# STAMFORD ROAD SAFETY AUDIT

ROUTE 137 (WASHINGTON BOULEVARD)

NOVEMBER 2023

Exhibit 38: Broad Street and Washington Boulevard intersection, view north

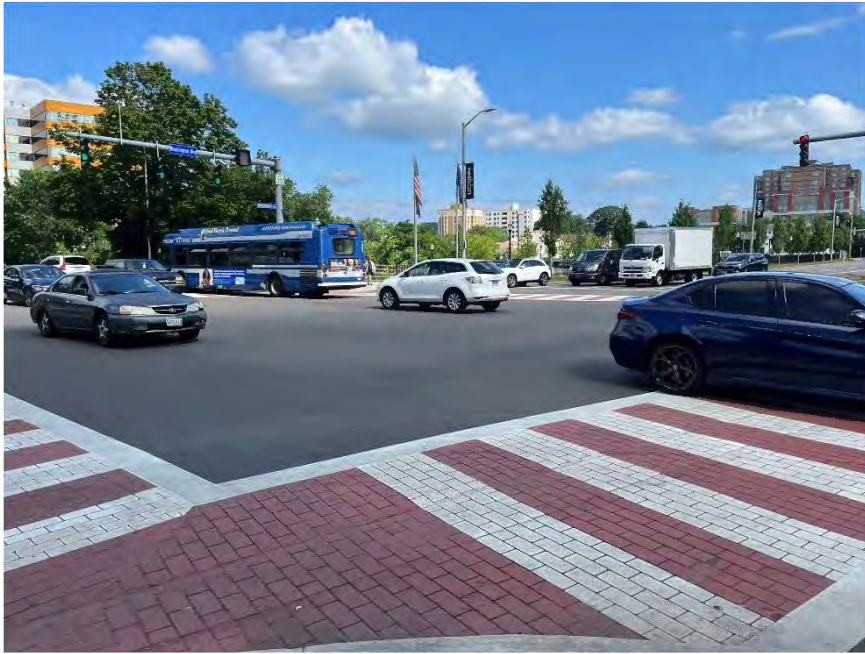
- Leading pedestrian intervals (LPIs) were discussed as it relates to left turn phasing. Some jurisdictions nationally have opted for a lagging left-turn phase when implementing an LPI. While this does not cause concern for the "yellow-trap" situation which is prohibited, this phasing is not typical of CTDOT standards.

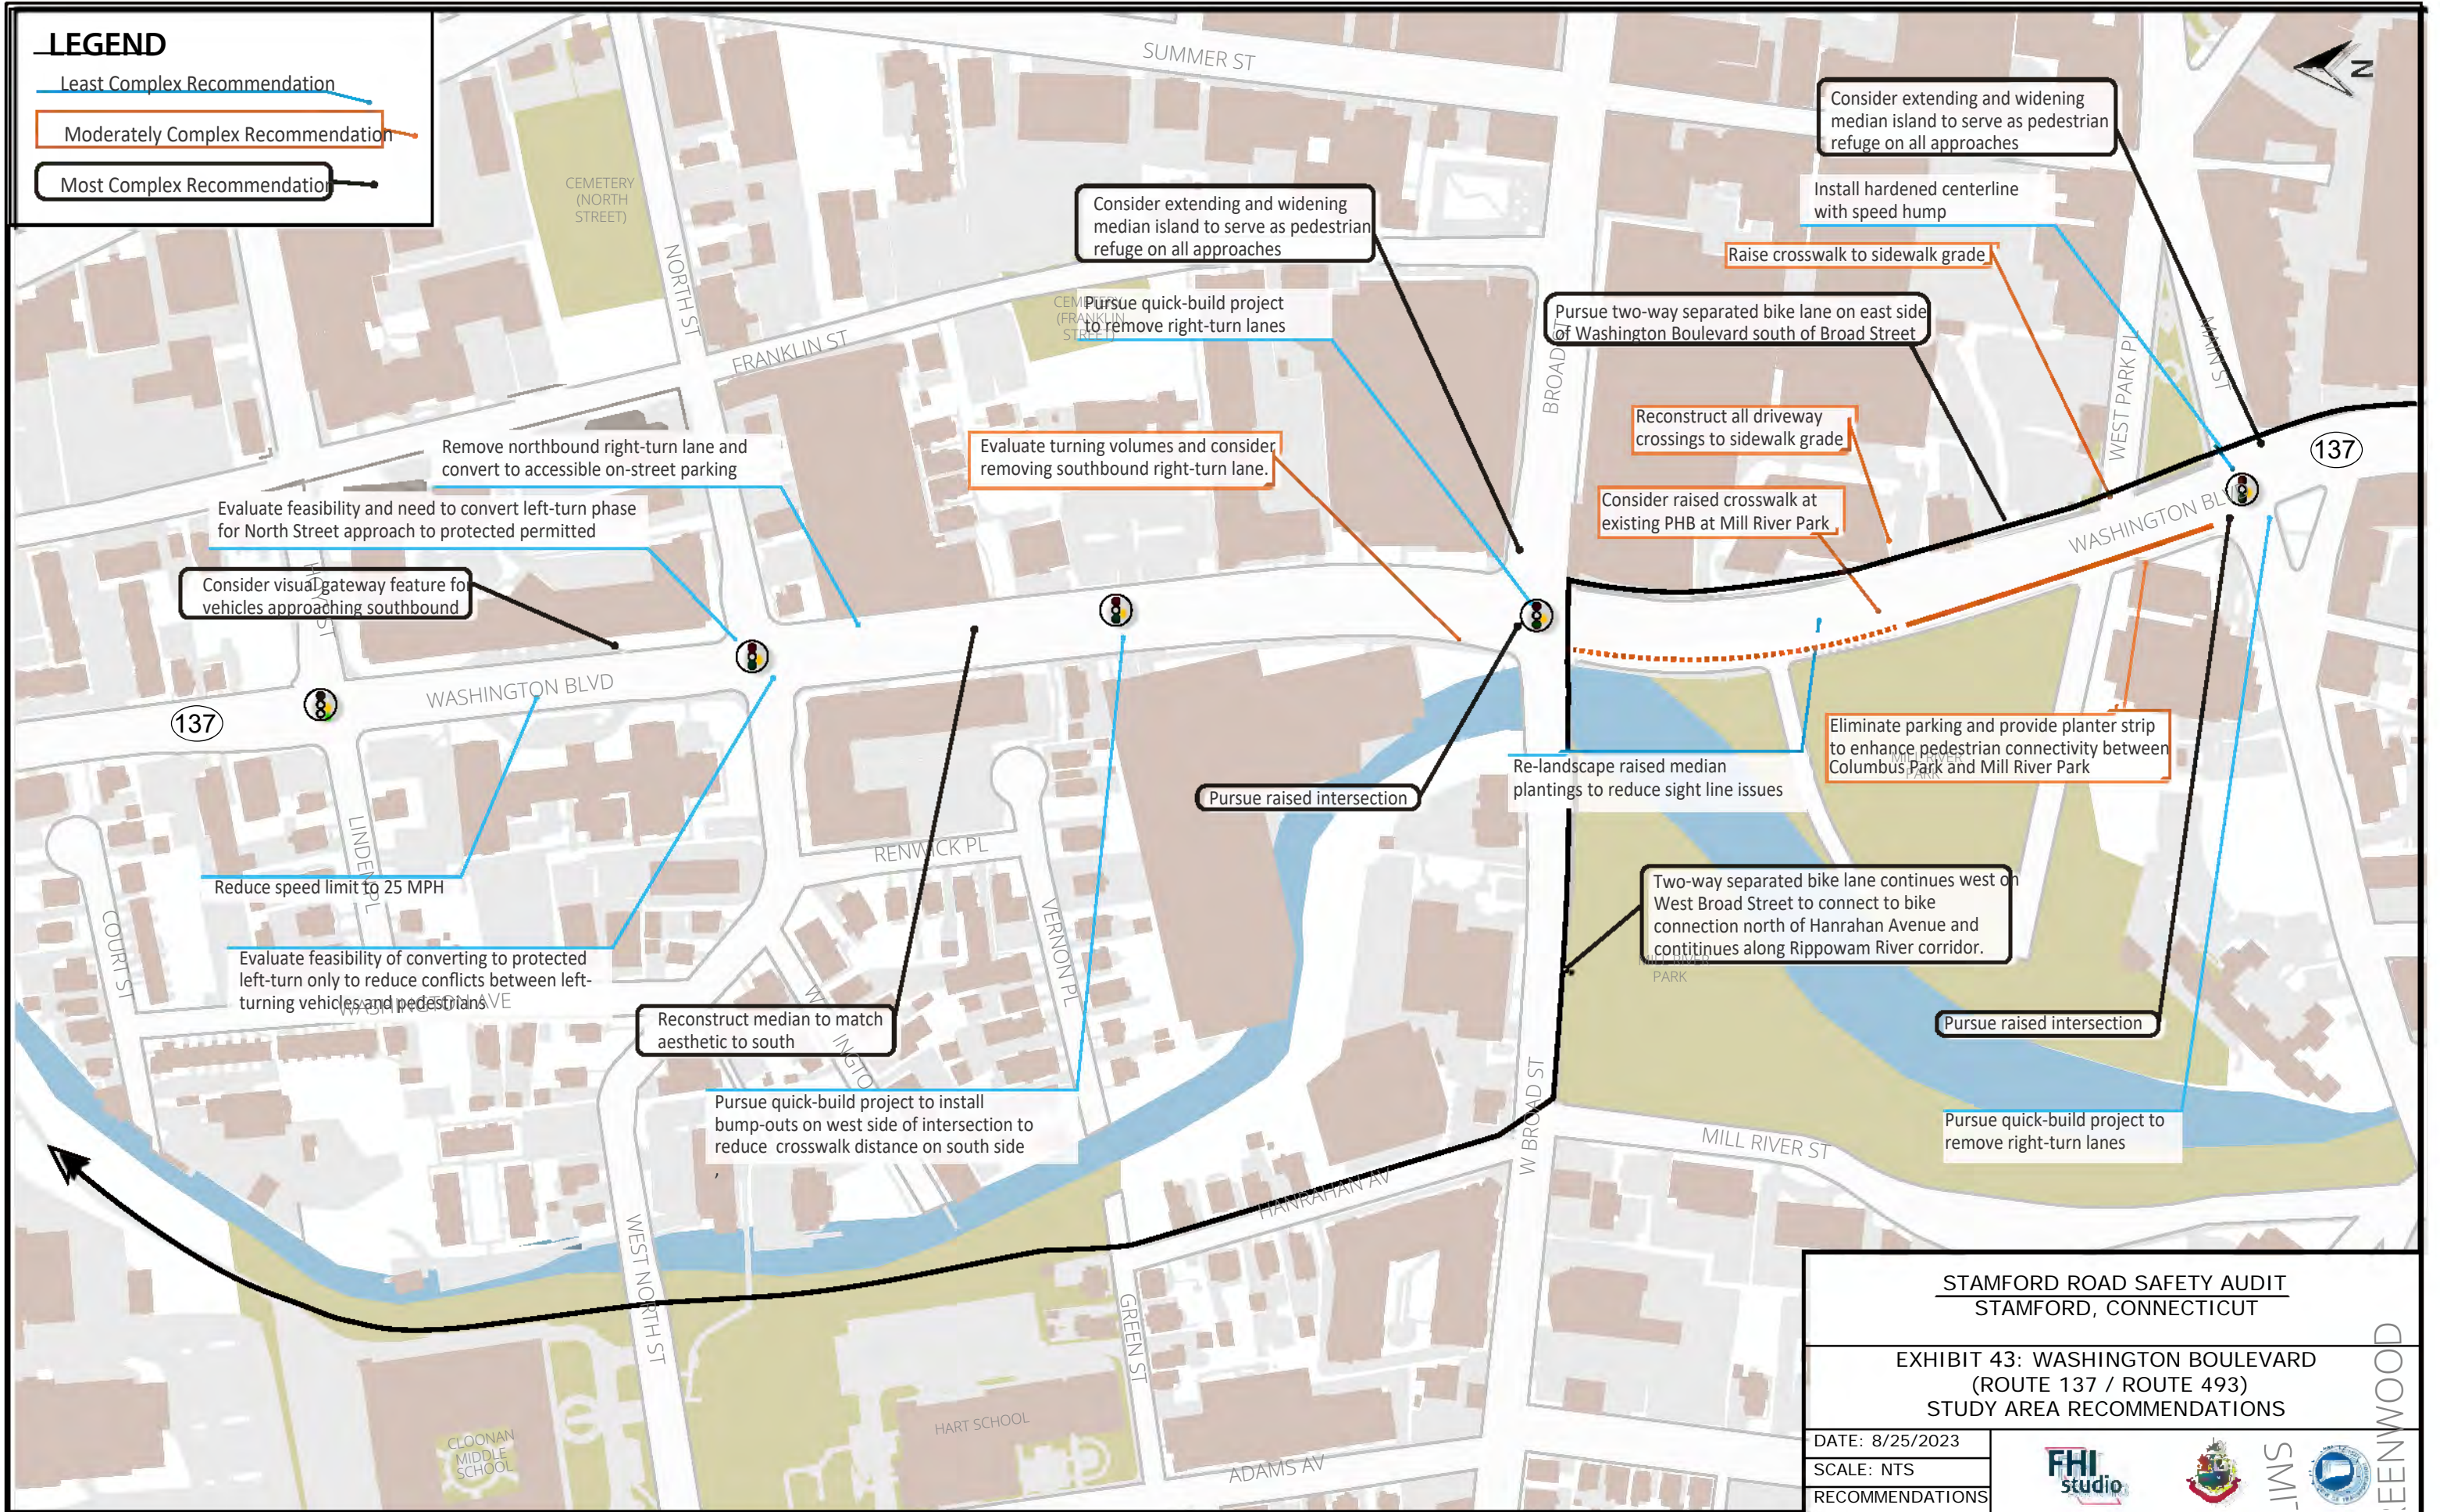
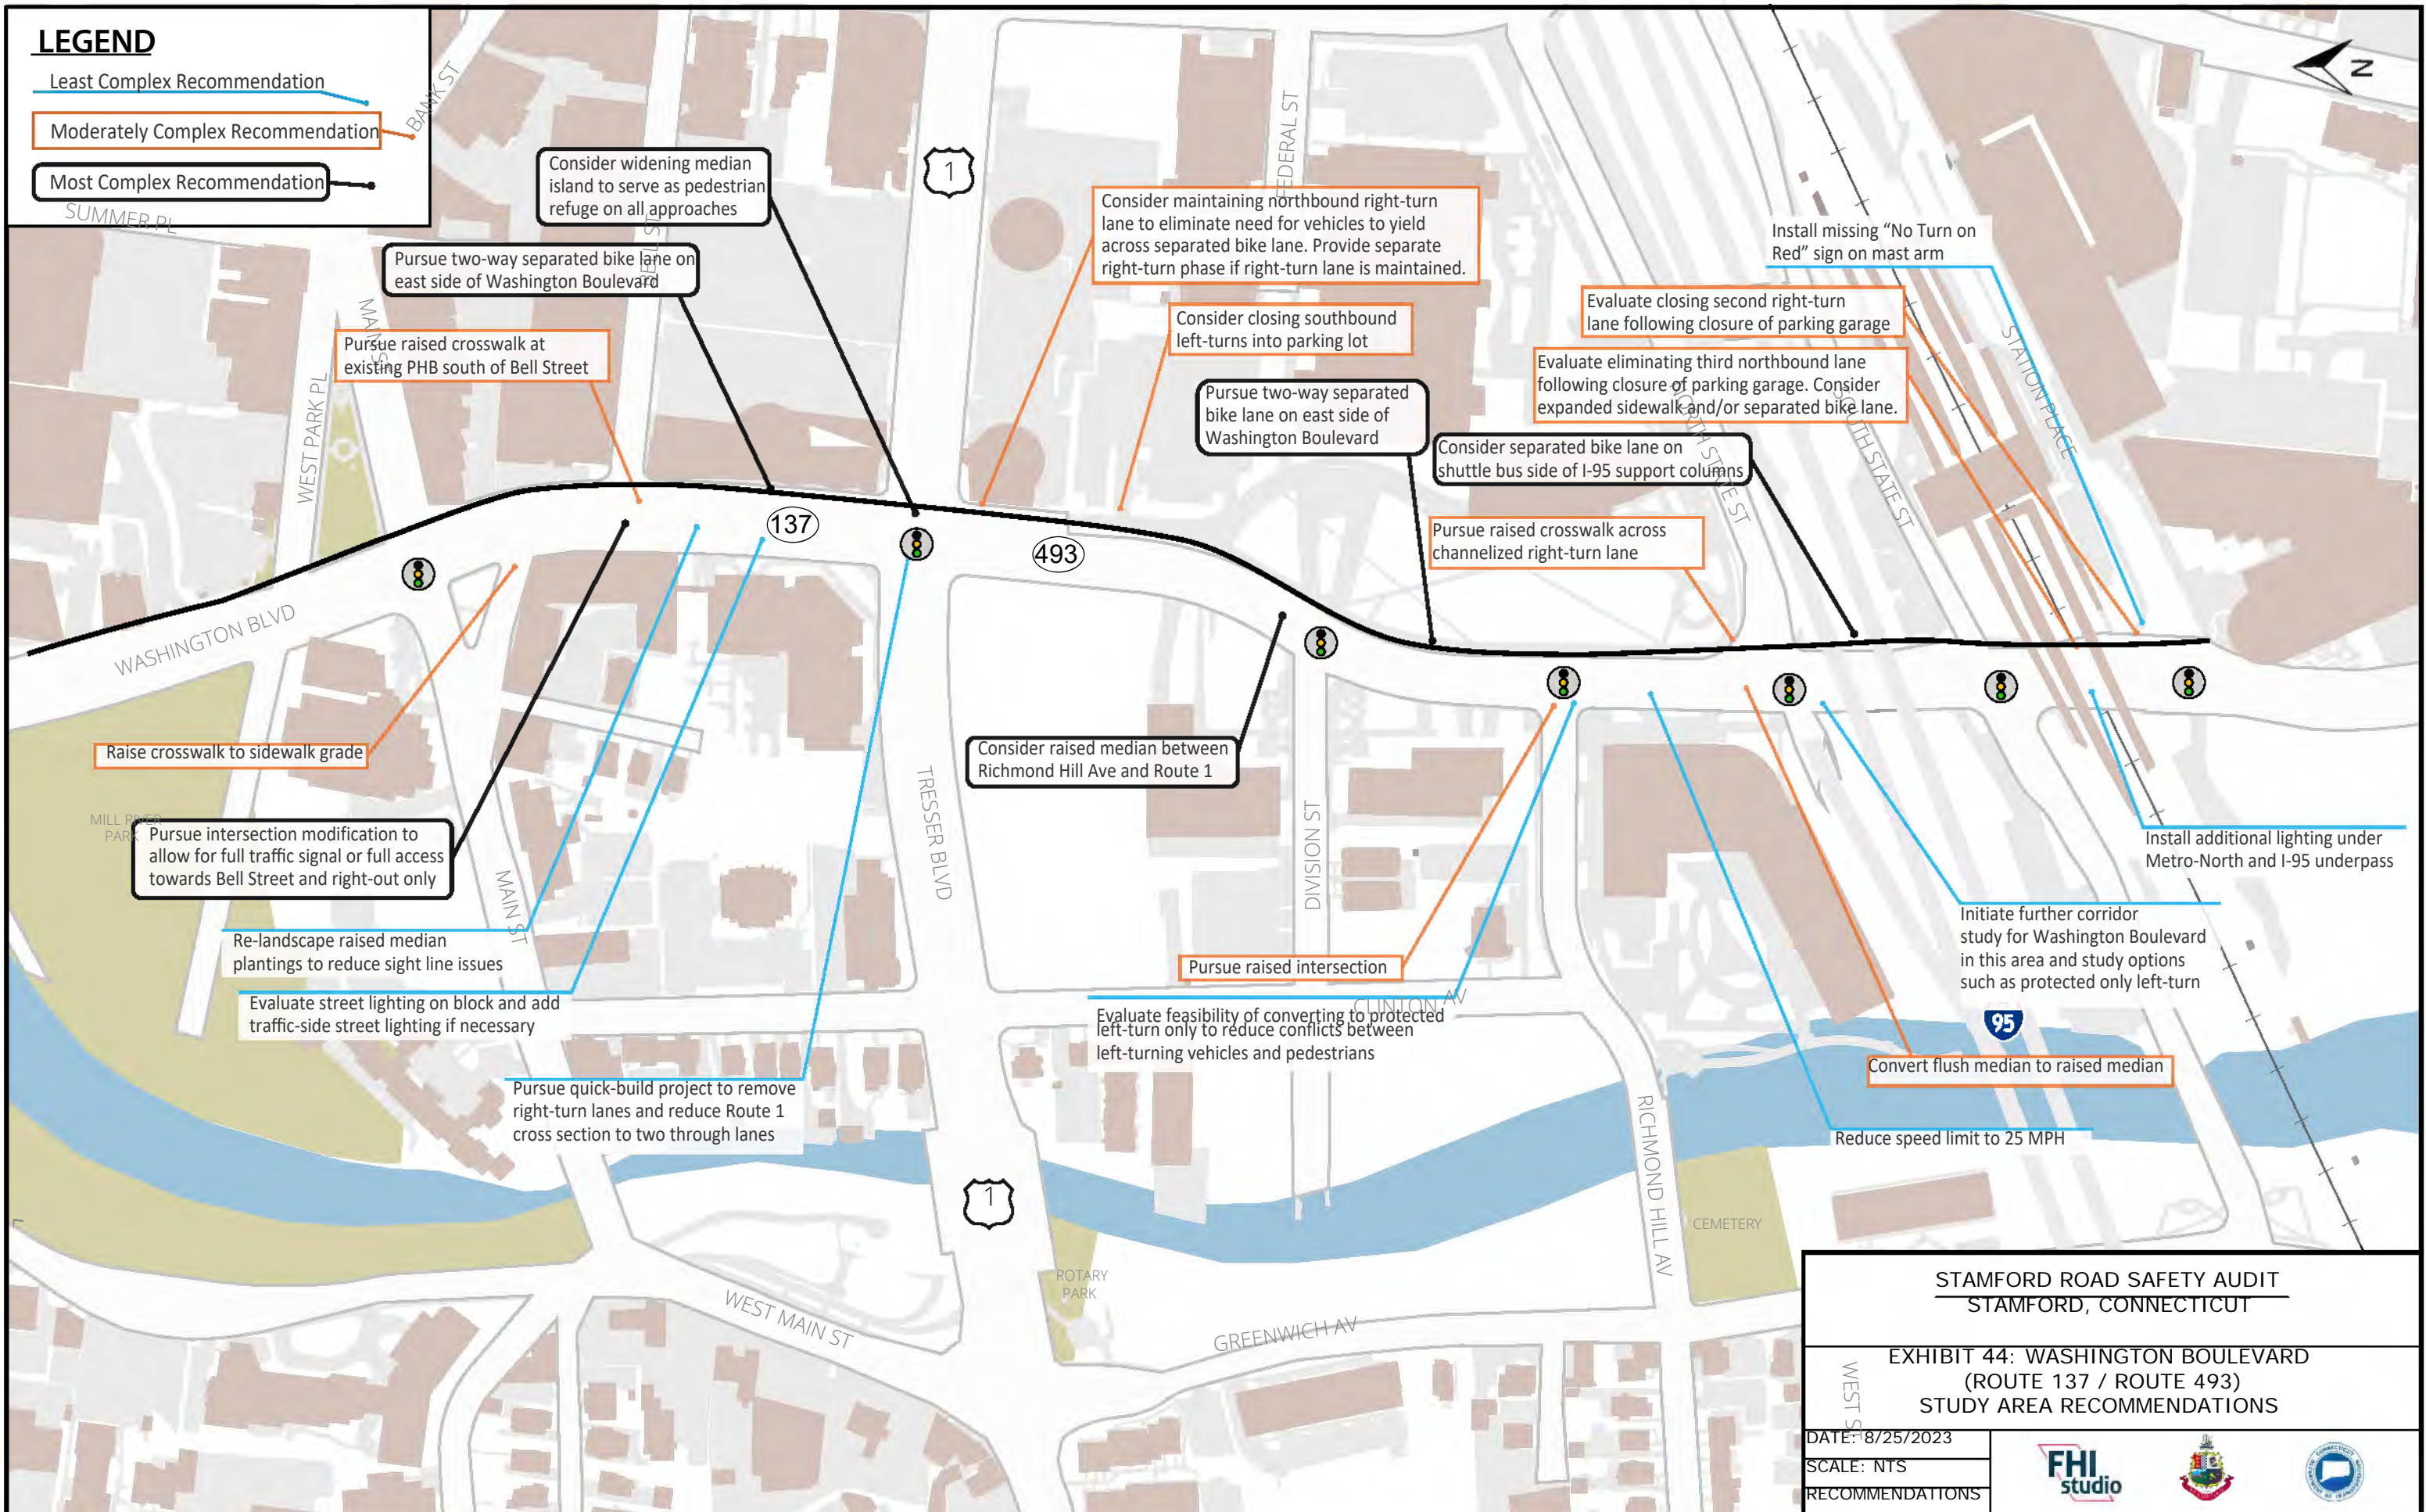
Consider widening median island to serve as pedestrian refuge on all approaches

Consider maintaining northbound right-turn lane to eliminate need for vehicles to yield across separated bike lane. Provide separate right-turn phase if right-turn lane is maintained.

Pursue intersection modification to allow for full traffic signal or full access towards Bell Street and right-out only

Re-landscape raised median plantings to reduce sight line issues

Evaluate street lighting on block and add traffic-side street lighting if necessary

Pursue quick-build project to remove right-turn lanes and reduce Route 1 cross section to two through lanes
